BEFORE THE ENVIRONMENTAL QUALITY COUNCIL
STATE OF WYOMING

In re Brook Mining Co., LLC coal mine)
permit – PT0841) EQC Docket No. _____
)
)

**PETITION FOR HEARING FOR ENVIRONMENTAL QUALITY COUNCIL REVIEW
OF THE DEPARTMENT OF ENVIRONMENTAL QUALITY DIRECTOR’S
APPROVAL OF THE COAL MINE PERMIT APPLICATION SUBMITTED BY
BROOK MINING CO., LLC (PT0841)**

FIGURE 2 NEW PROPOSED MINE PLAN OF THE BROOK MINE SHOWING THE ADJACENT OLD WORKS

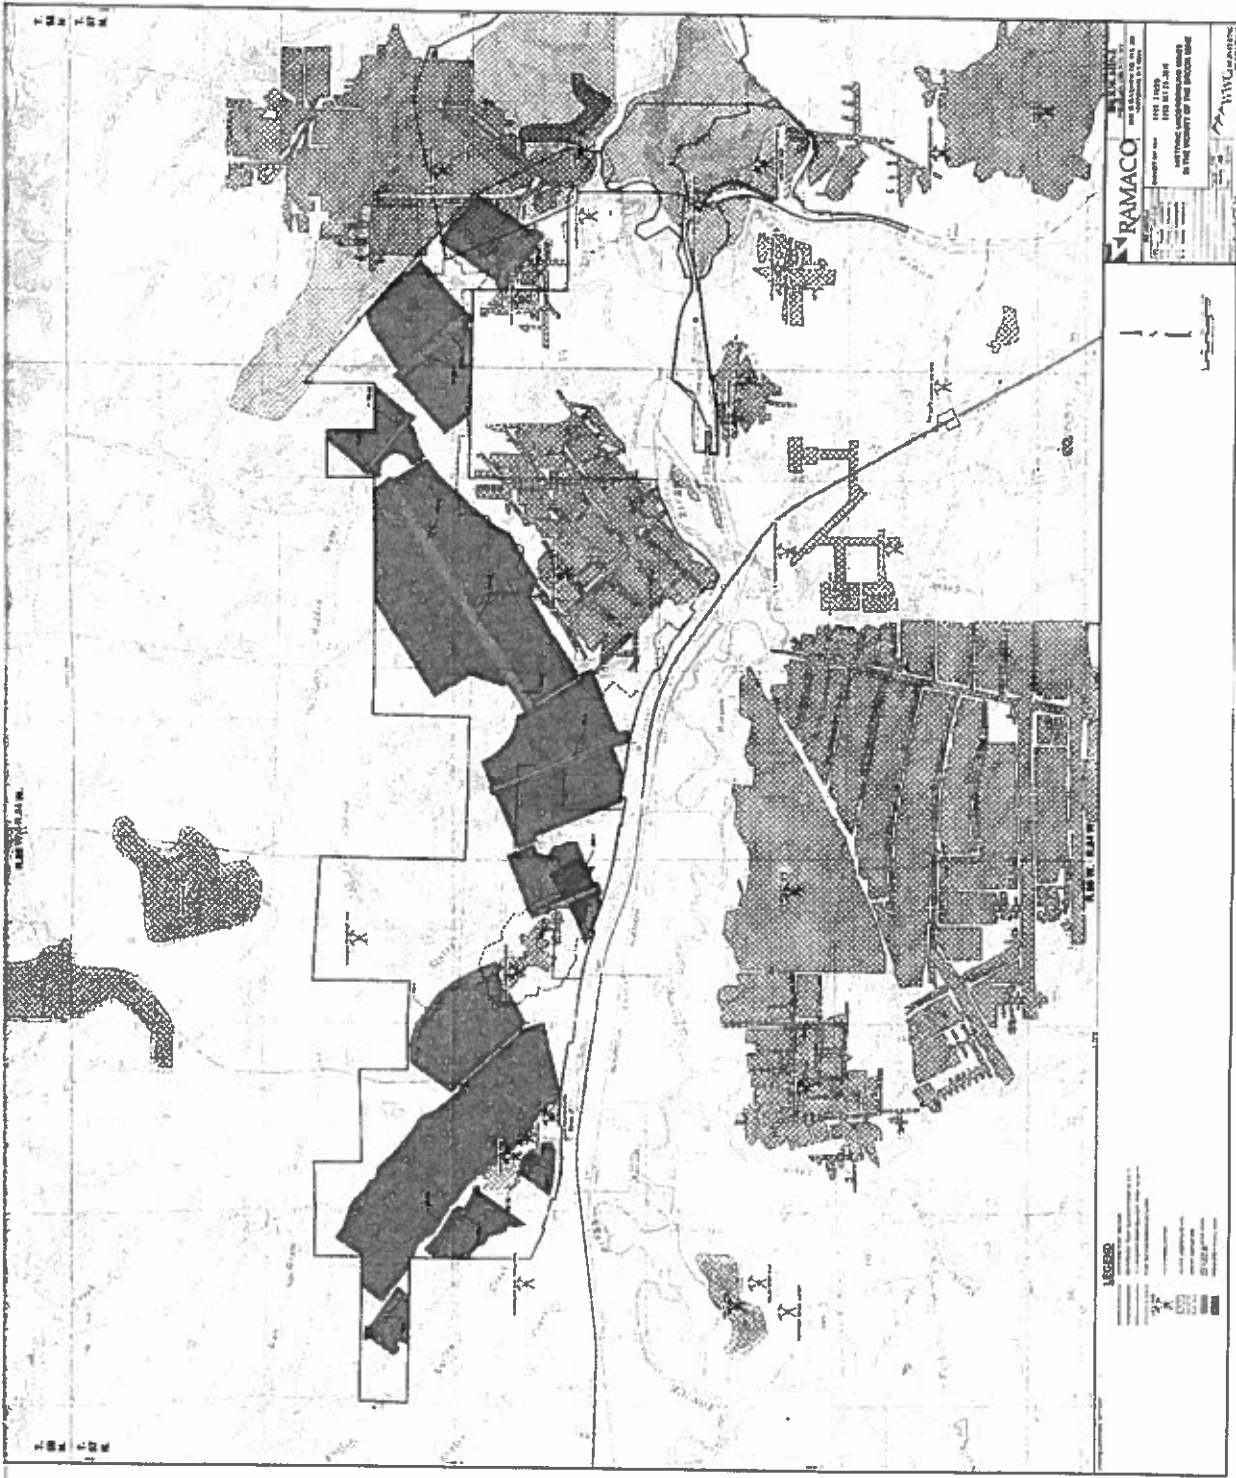
The new proposed HWM TR-1 area consists of only one block (in lieu Blocks 3 and 4 formerly TR-2, see MEA, 2017). The new mine plan is shown in Figure 2. Comparing Figure 4.3 (MEA, 2017) to Figure 2, it appears the changes in the mine plan only pertain to the old TR-1 and TR-2 areas. Consequently, the HWM areas which were Blocks 9 and 16 in Figure 4.3 still abut against old workings with minimum barrier coal of 0 to 70 ft. and consequently result in potentially flooding from the old workings to the south especially considering the likely inaccuracies of the mine map of the old works. Based on historical mapping, the floor depths in the minimum barrier areas are about 87 to 115 ft. in the new TR-4B, 5, and 7 areas. See Figure 2. Based on various empirical relationships on the minimum confirmed barrier thickness, this barrier should be at least about 55 to 110 ft. (Koehler and Tadolini, 1995), and therefore all areas (TR-4B, 5, and 7) would exceed the

FIGURE 3 SKETCHES OF THE THREE PRINCIPAL MODES OF FAILURE OF ROOM-AND-PILLAR MINE WORKINGS WHICH CAN RESULT IN SURFACE SUBSIDENCE

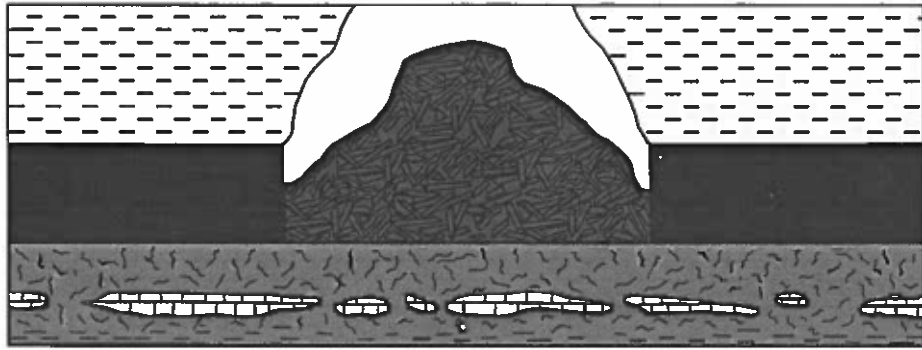
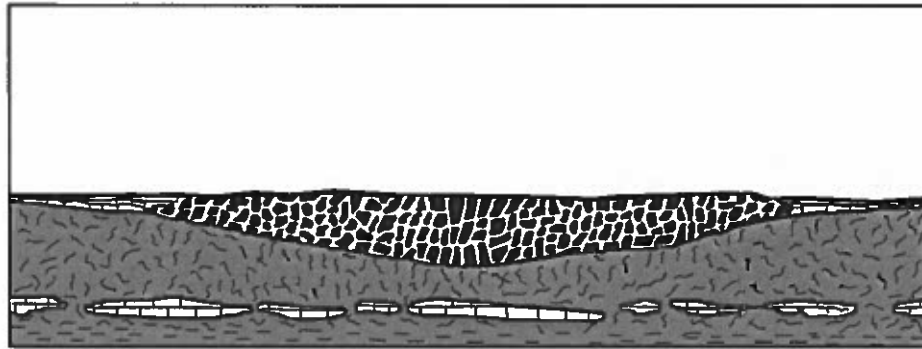
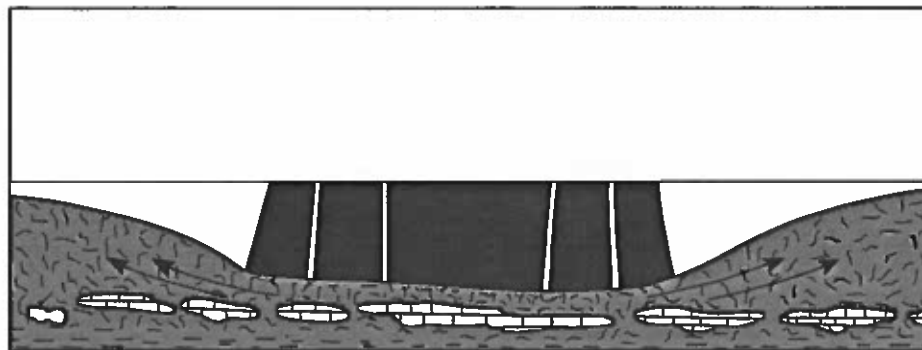
Below is the review of limited AAI mine design analyses against mine roof, pillar and floor failure based on the information available in the AAI report. See Figure 3.

FIGURE 1
OVERALL PROPOSED MINING AREA WITH CURRENTLY-PROPOSED HIGHWALL MINING AREA
BROOK MINE, SHERIDAN COUNTY, WYOMING

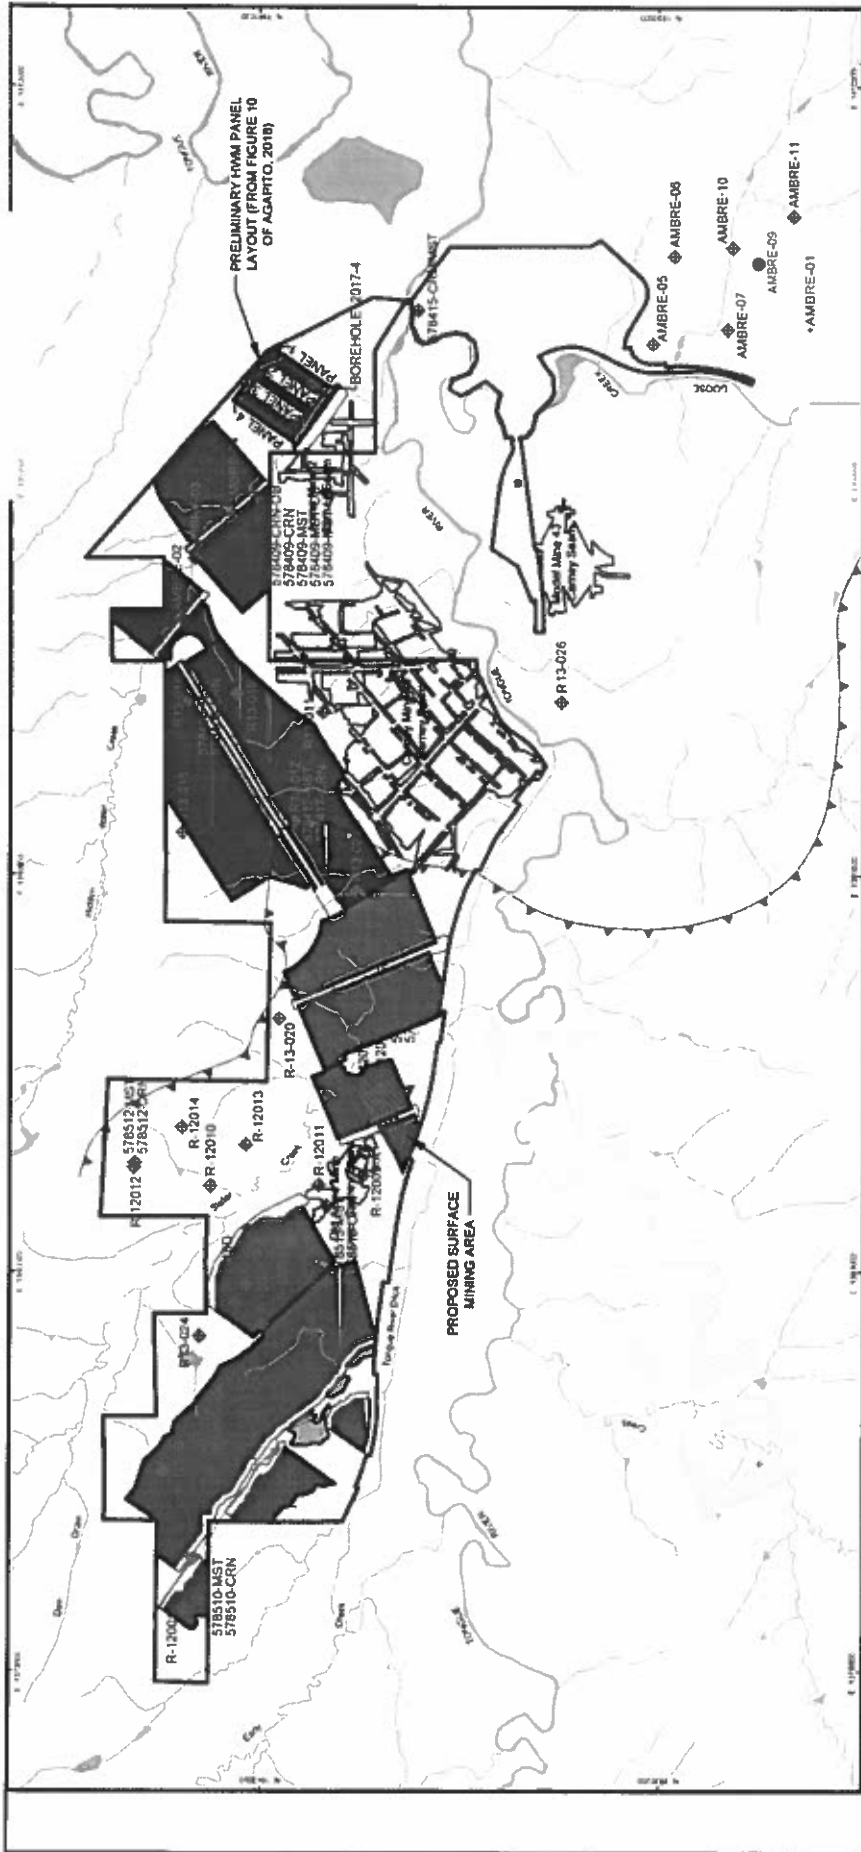
It appears that Agapito (AAI, 2018) relied upon the geotechnical parameters from a single core hole (2017-4) for their geotechnical analysis, modeling and subsidence prediction. The location of core hole 2017-4 is shown on Figure 1. Reference is made in AAI (2018) to additional holes which were used to develop the stratigraphic model, but the specific holes used are not referenced, nor are the associated logs provided.

In our opinion, the single core hole (2017-4) does not adequately characterize the stratigraphy or the geotechnical properties of the rock in the immediate area of the proposed TR-1 highwall mining area. From our review of the maps and geologic cross sections in Appendix D5 (Ramaco, 2019a), we note that most of the existing core holes are located well to the west of the TR-1 area. These core hole locations have been overlaid onto the overall mine plan on our Figure 1. We reviewed Cross-Section K-K' on Sheet 14 of Addendum D5-3 Exhibit 2, and it appears that the closest core holes to 2017-4 are 578409 and 578415 which are located well outside the proposed TR-1 mining area at a distance of approximately 3,100 and 3,300 feet from core hole 2017-4, respectively (see Figure 1). In our opinion, this distance between core holes is excessive and does not allow an adequate characterization of the TR-1 area. We recommend that
